Newell Boathouse Renovations

Notice of Intent – Supplemental Information

April 27, 2022

Formal Response to Hearing Comments

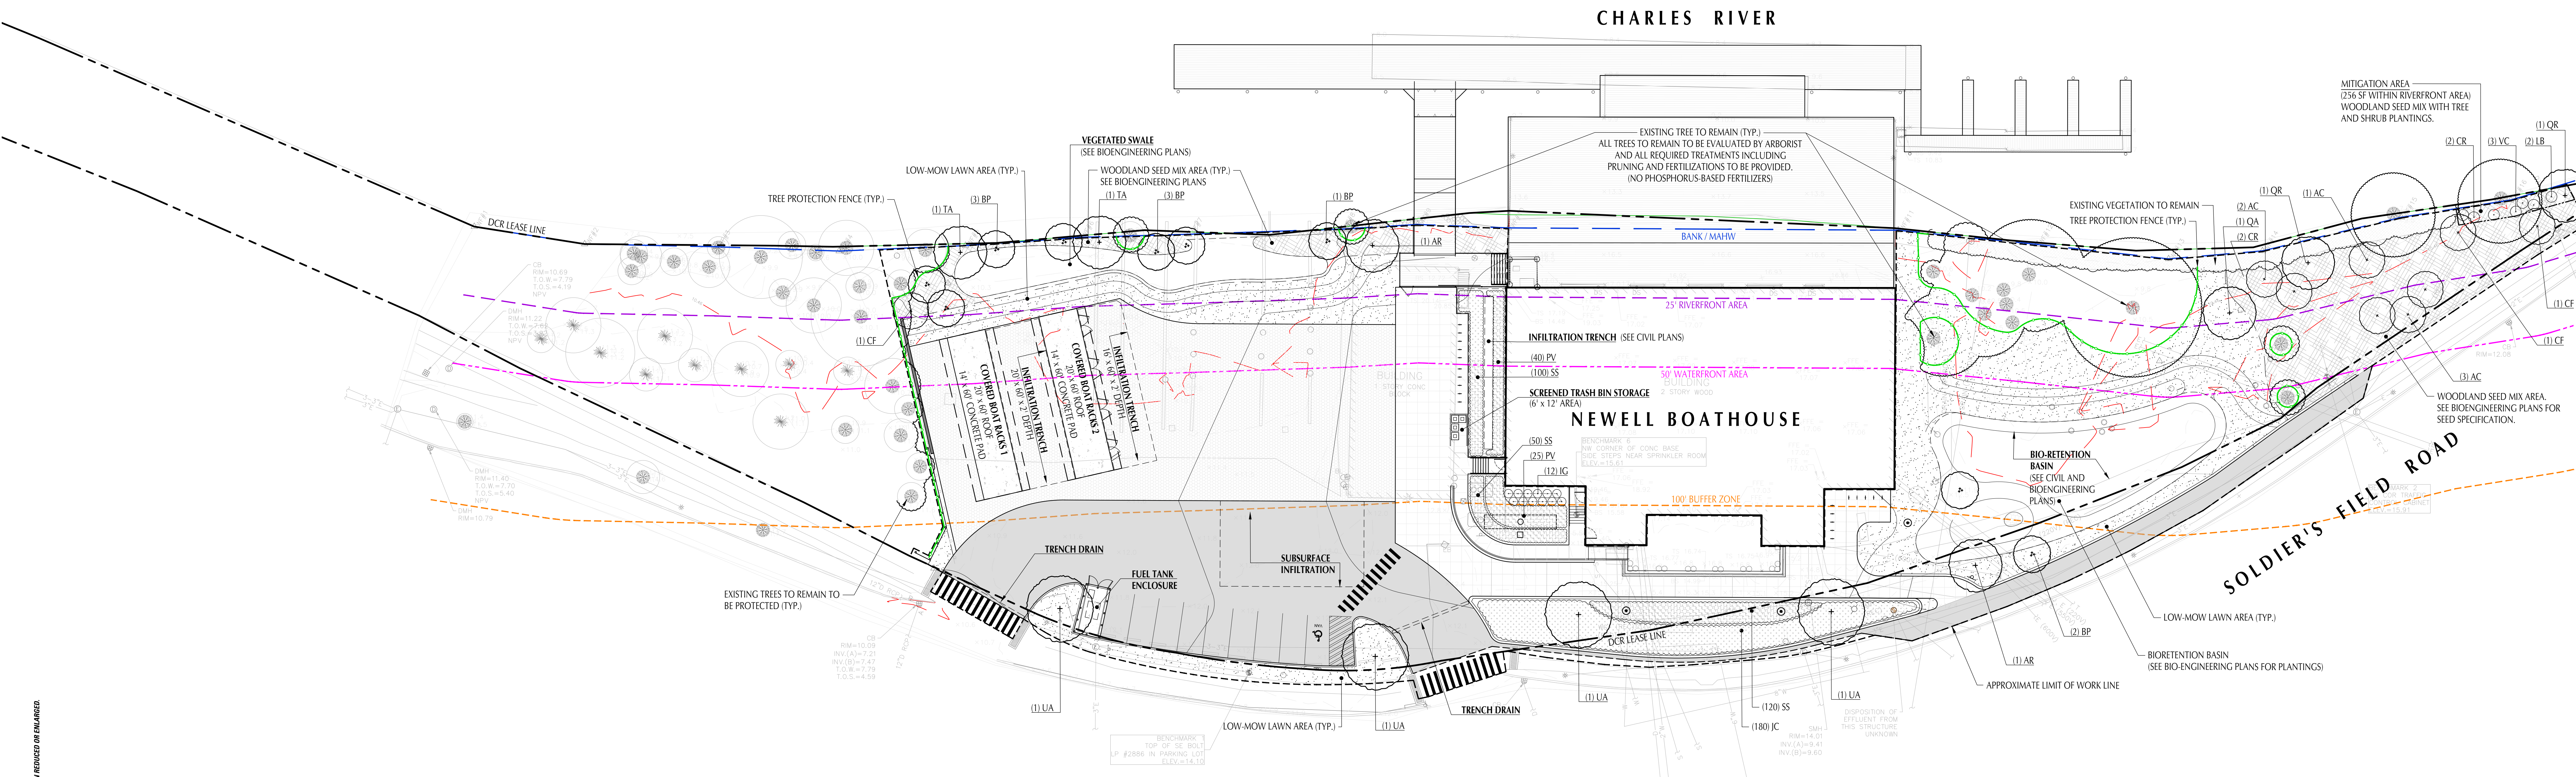
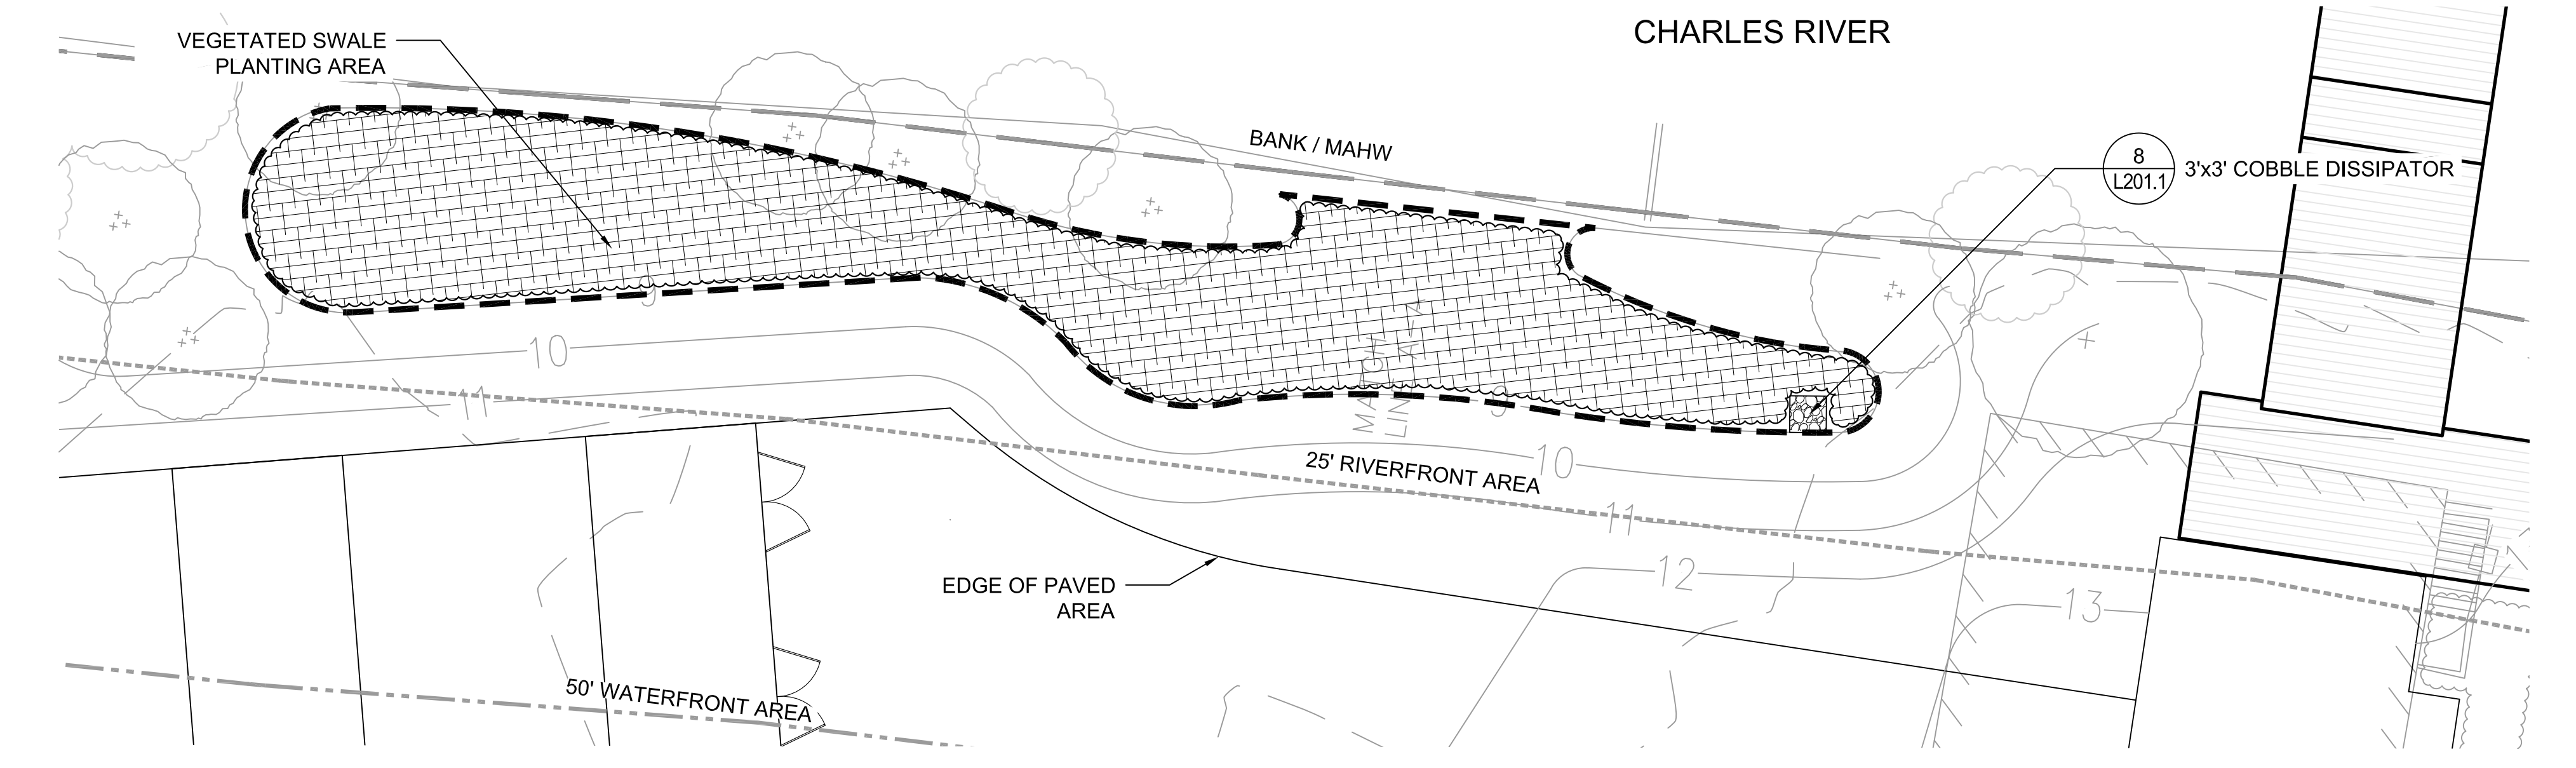
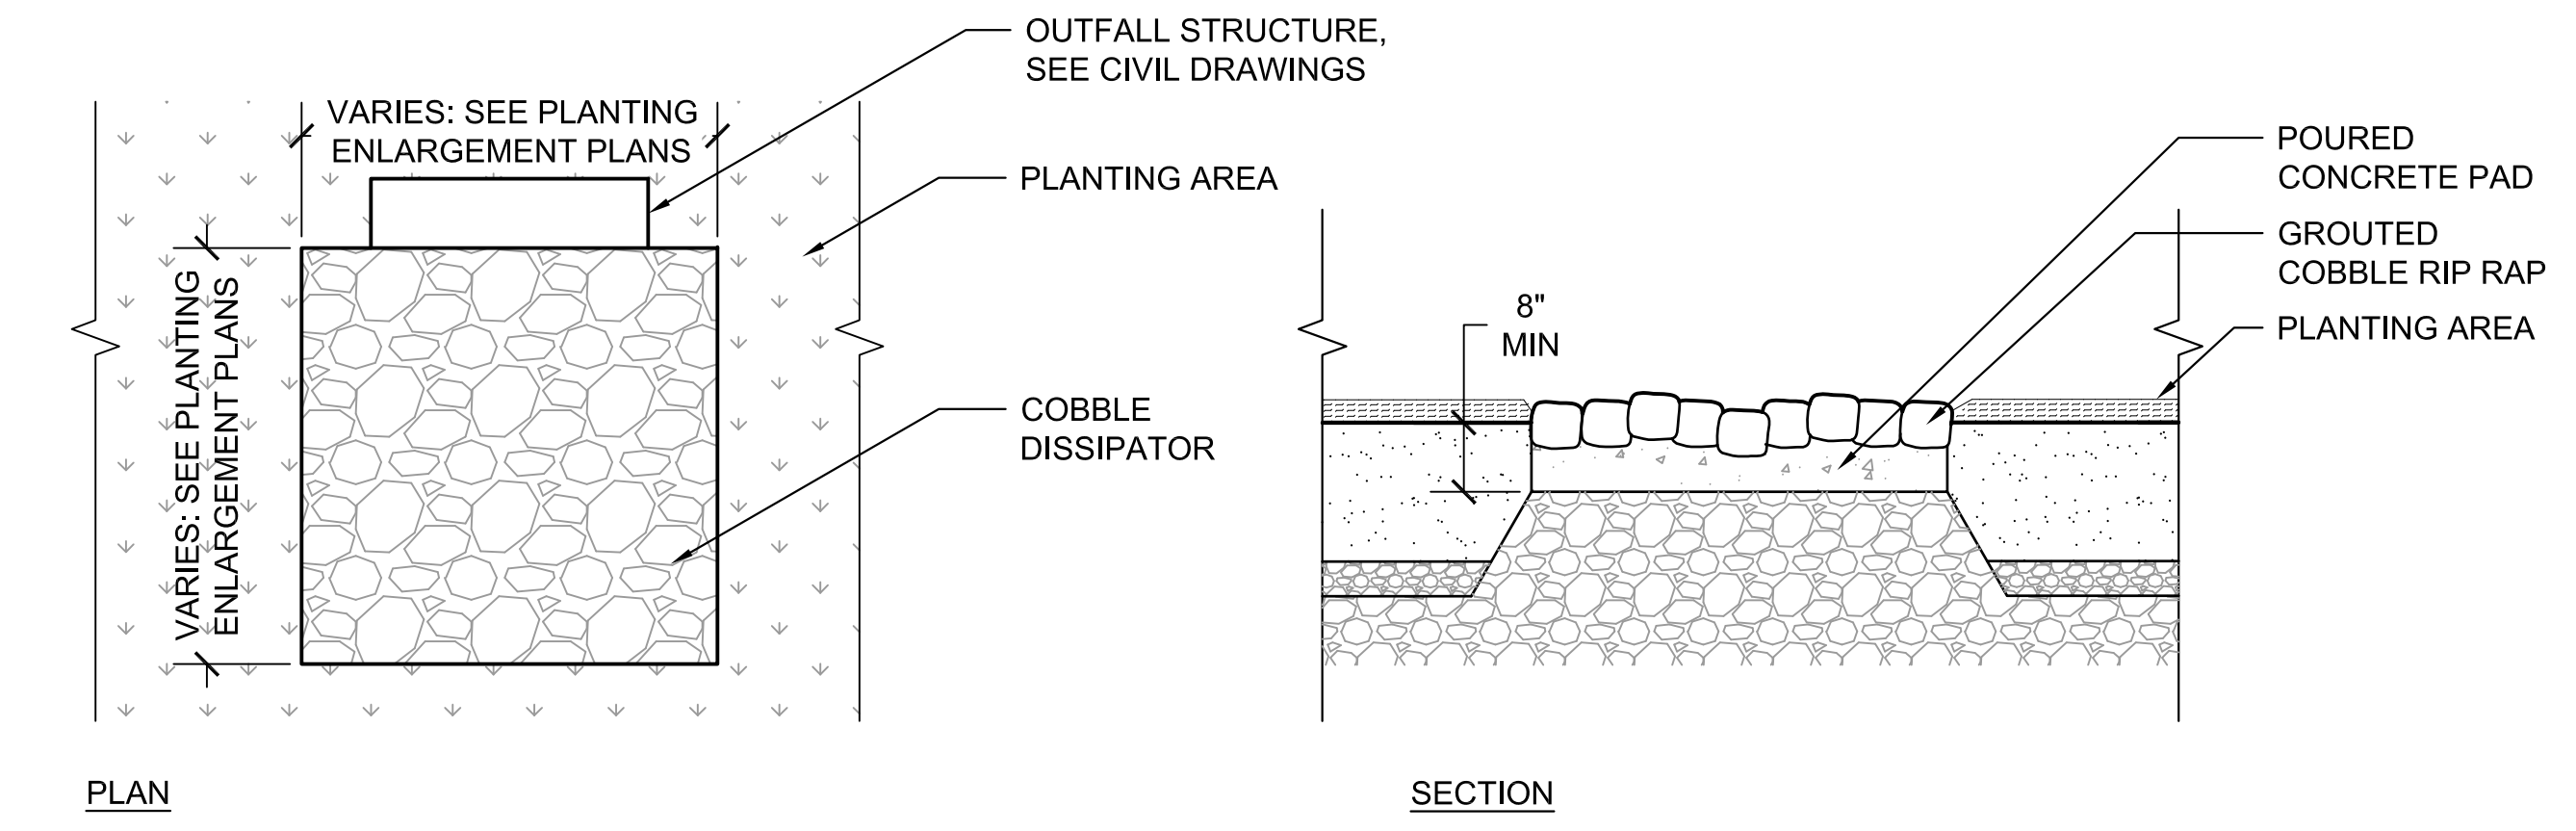
13	Commissioner Sullivan requested additional phosphorus reduction and additional flood storage.	Please see attached for the narrative and calcs relating to phosphorus reduction from the SW Report. There have been some minor revisions since the SW Report was submitted. As mentioned in Item 1, we have revised our design to provide a net cut within the flood plain. Please see attached for our revised flood storage figure.	G,B
14	Commissioner Ghirin requested a revised plan showing the boat rack structures removed entirely from the Waterfront Area.	The attached alternatives analysis shows one of the options with the boat racks out of the waterfront area.	F
15	Commissioner Thiruvengadam requested clarifying the locations of some of the items on the plan, specifically the bike path and pedestrian areas.	We have added some additional labeling and included a sheet with the bike path highlighted. We also believe that the Commissioner also asked for an educational sign to be placed next to the bioretention basin, this is acceptable to us and it has been added to the updated landscape plan.	A,H

We are proposing to take a section of the site on the southern end that is currently lawn where an existing line of riverbank plantings end and add plantings into that area to enhance the area and turn it into a more ecologically friendly area. More details are shown on the revised landscape drawings in Attachment A.

NEWELL EXISTING PILE PLAN
SCALE: 1"=20'-0"

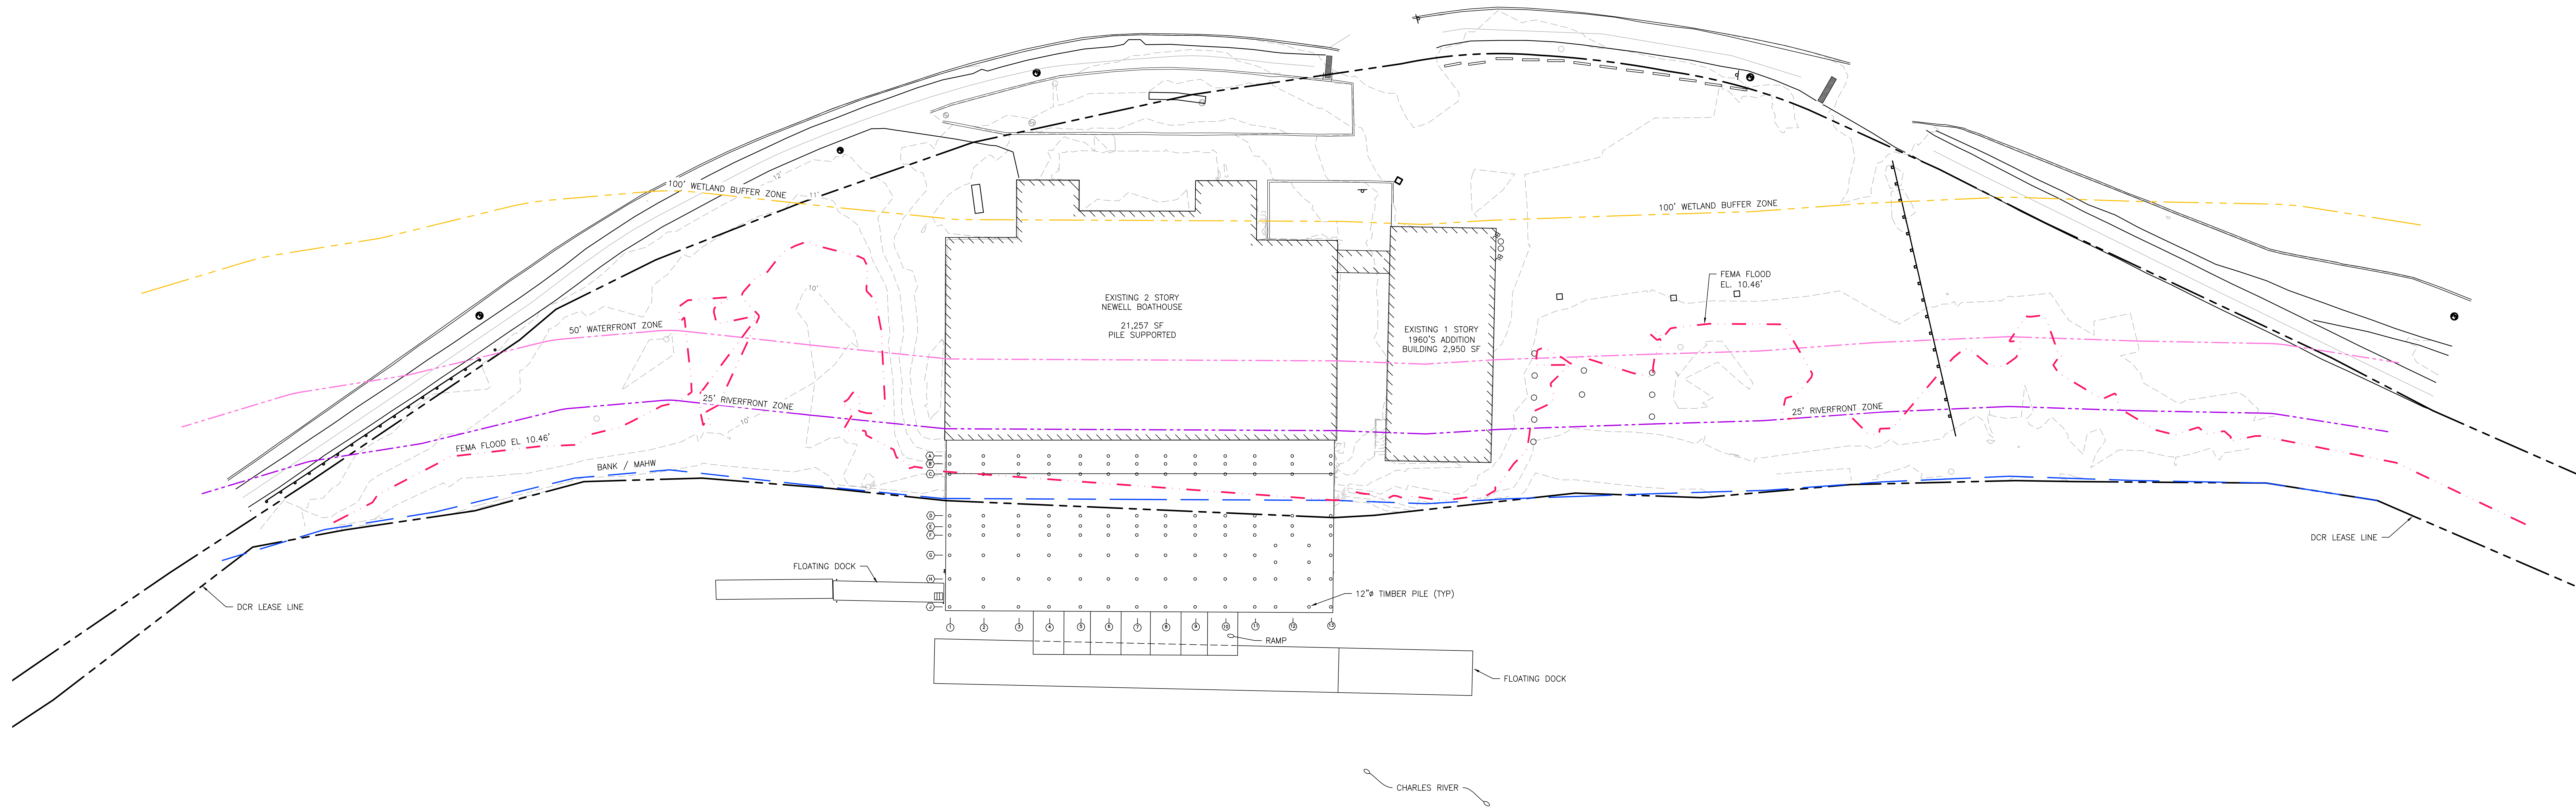
4	Regarding the plan set, each sheet indicates that the MAHW line and Bank are coincident but the MS sheets indicate that the Bank is a separate topo line at elevation 9ft. Which is correct?	The MS drawings have been updated and any confusing or conflicting notes have been removed. The MAHW line is correct and was flagged as part of the topographic survey done for the project. The updated drawings are attached.	A
5	In addition to the Norway Maple, what other invasive species are present onsite? What treatment methods are proposed to remove the invasives?	No invasive species have been documented in the project area other than the Norway Maples. These trees are proposed to be removed and stumps ground out.	-
6	Can you confirm how many trees are being removed? Does that include trees with less than 6in DBH? Can you confirm how many trees are being planted as part of the project?	Twenty-six (26) existing trees are proposed to be removed. Six (6) of these trees are less than 6" in diameter. Twenty-eight (28) trees are proposed as part of the project.	-
